From: Andrew Tull <andrew.tull@3j-consulting.com>
Sent: Tuesday, April 03, 2018 5:11 PM
To: Brett Kelter
Cc: Dennis Egner; Liden; Alex Roller
Subject: RE: completeness letter for Lake Rd fields project (CSU-2018-001)
Attachments: 2-0.pdf; 5-5.pdf

Subject: completeness letter for Lake Rd fields project (CSU-2018-001)

OVERALL SITE PLAN
MILWAUKIE HS LAKE RD FIELD IMPROVEMENTS
MILWAUKIE, OREGON

5.5

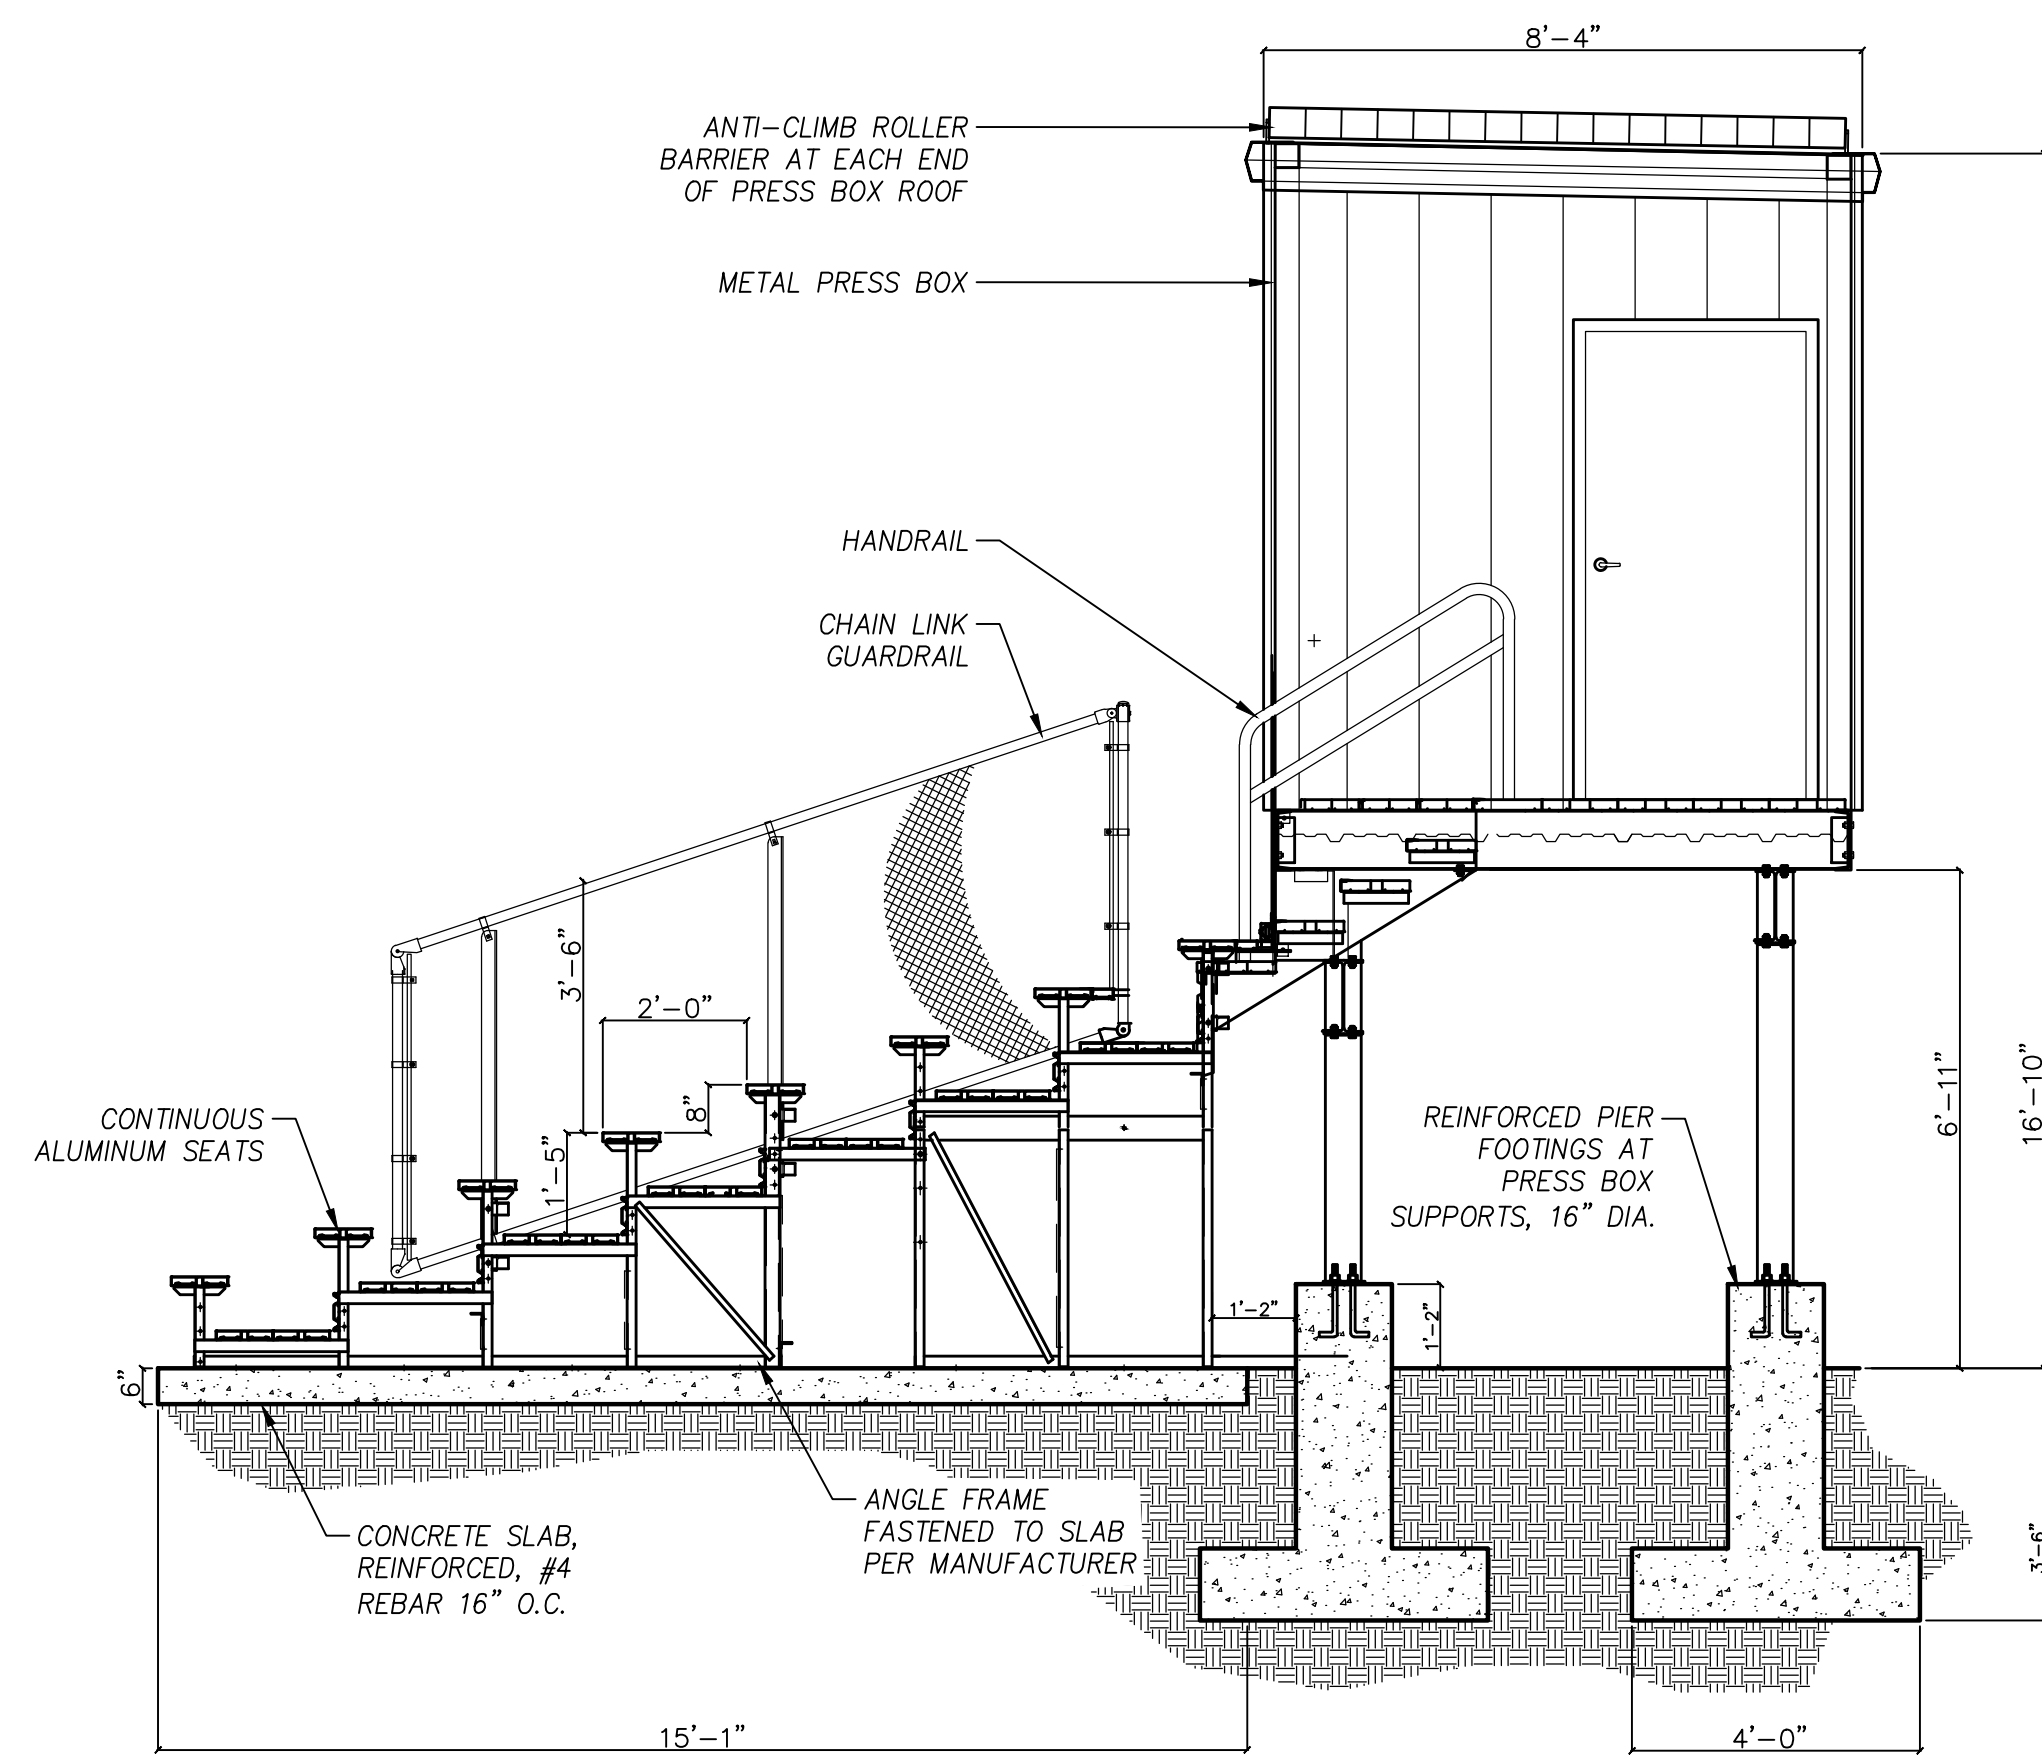
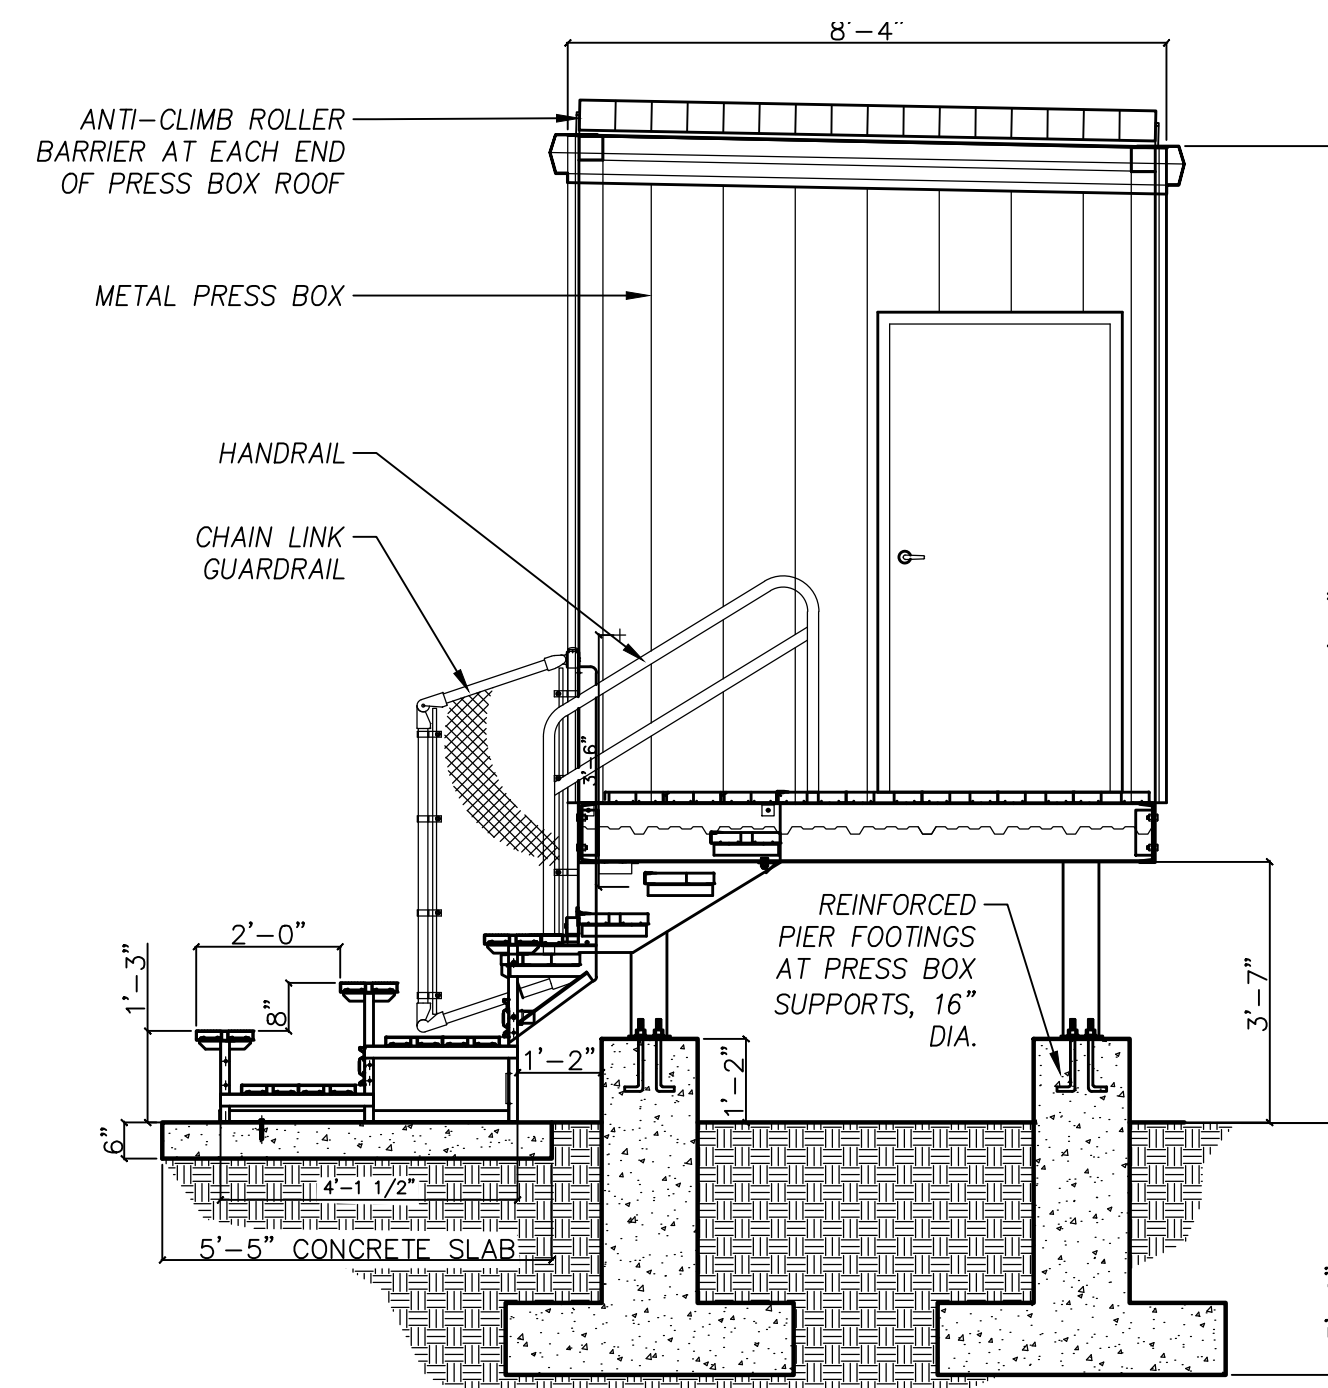
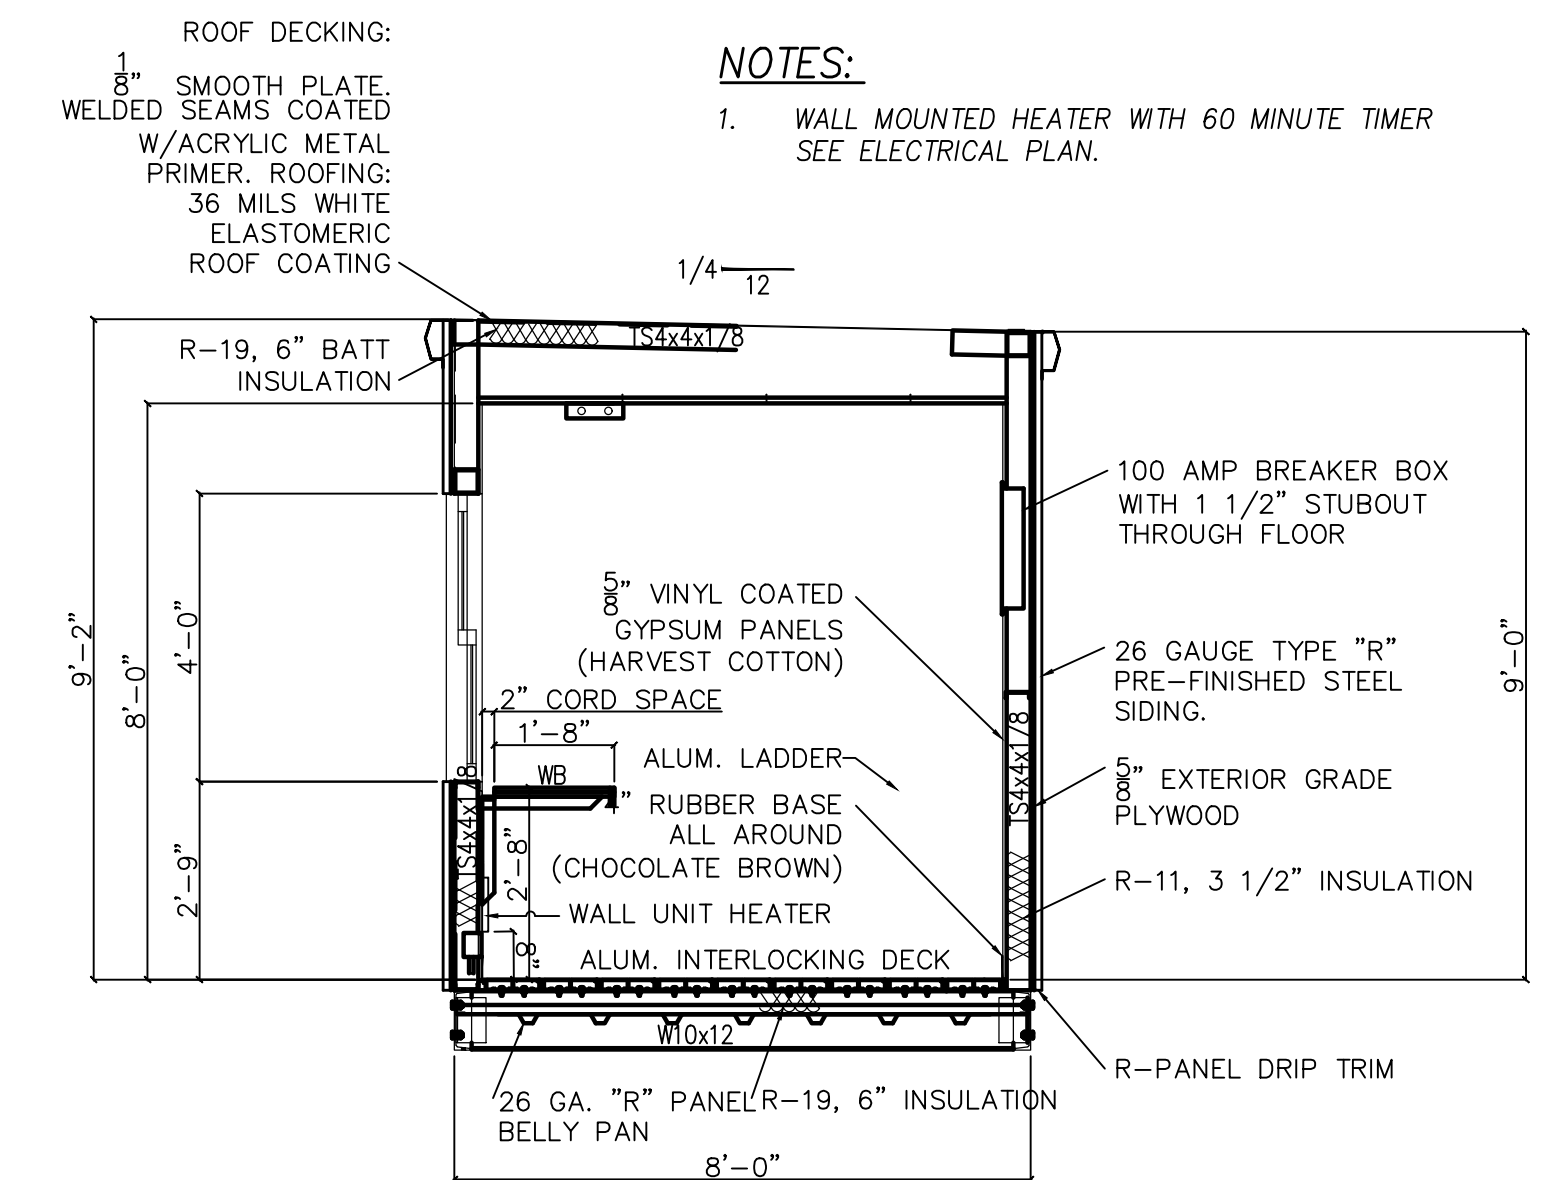
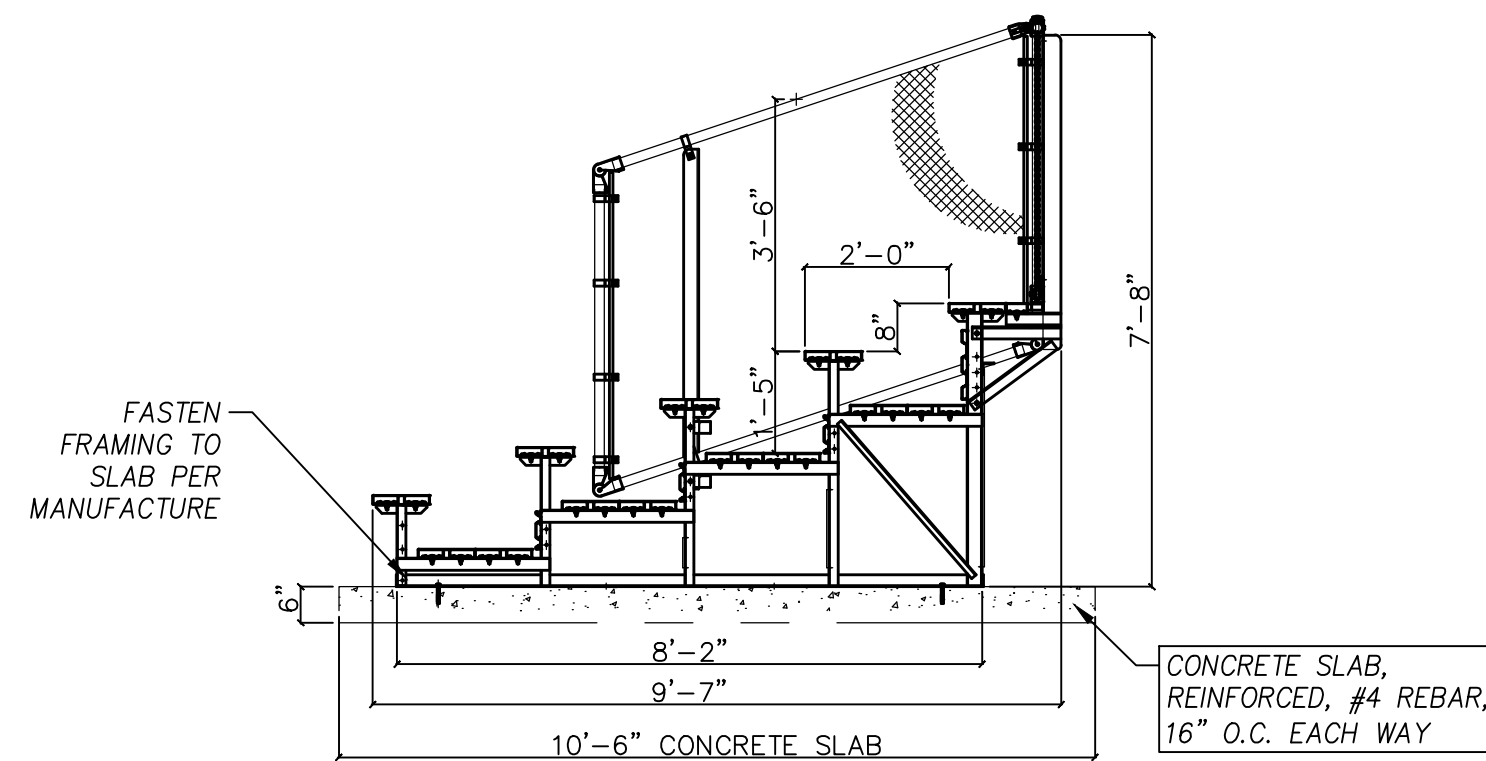
Accessory Structures – Regarding the requirements for accessory structures and a general consideration of the impacts of the proposed development, it would be helpful to see elevations of the proposed bleachers.

Elevations are attached – Plan 5-5.
